From: Mcconnell, DAVE P <dave.p.mcconnell@lmco.com>
Sent: Thursday, February 23, 2017 9:09 AM
To: Grant Robinson
Cc: Thomas Jacobson
Subject: MRB S/N A044-01378 - Repair of tip rib damage

Case Number: C0053830
Customer: Thai Aviation Services Limited
Aircraft S/N: 920279
Aircraft Model: S-92A
Aircraft TT: 762
ATA: 62
Part Number: 92150-09000-043
Case Subject: Request For Repair-MRB Tip Rib

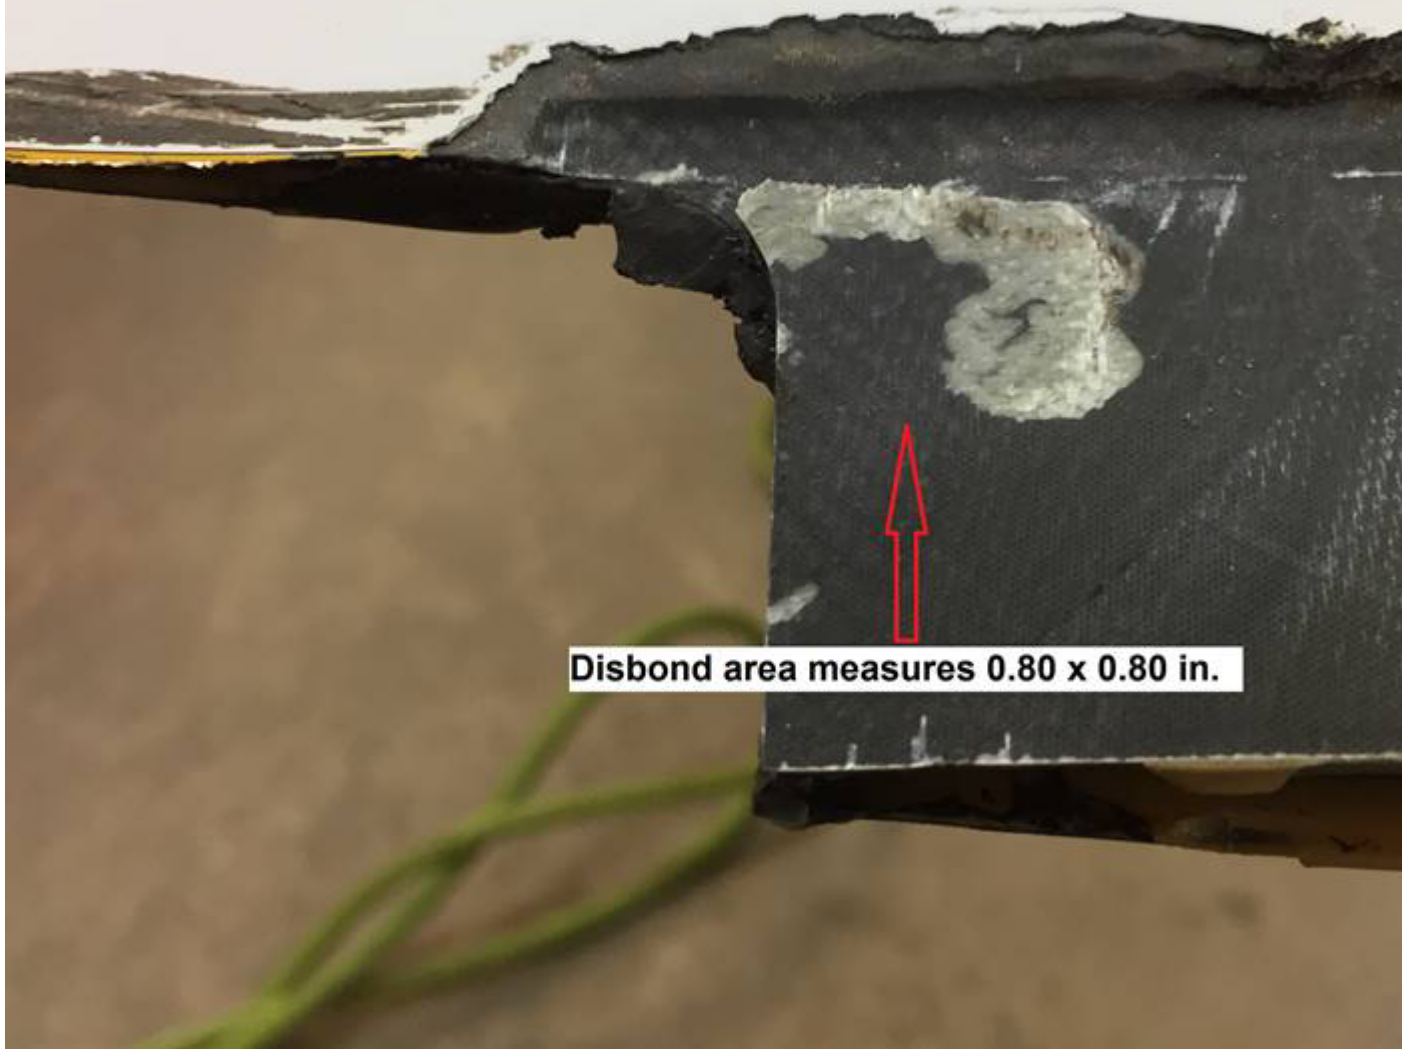
TAS maintainers attempted to remove the factory original tip cap on MRB S/N A044-01378 due to erosion damage.

It was discovered that the tip cap had been installed bedded in wet Proseal.

Upon removal of the tip cap it was found that an area of fiberglass measuring approximately 0.80 x 0.80 inches had torn and lifted from the upper tip rib trailing edge.

This damage is similar in nature but considerably lesser in extent to that reported in FTR 10614T005 CRM Log ID 65168.

TAS request a repair scheme on a Work Stop basis. EoM

As in the previously referenced FTR 10614T005 (Case XAu-65168), engineering recommends a 1 ply wet layup in the area per the SRM.
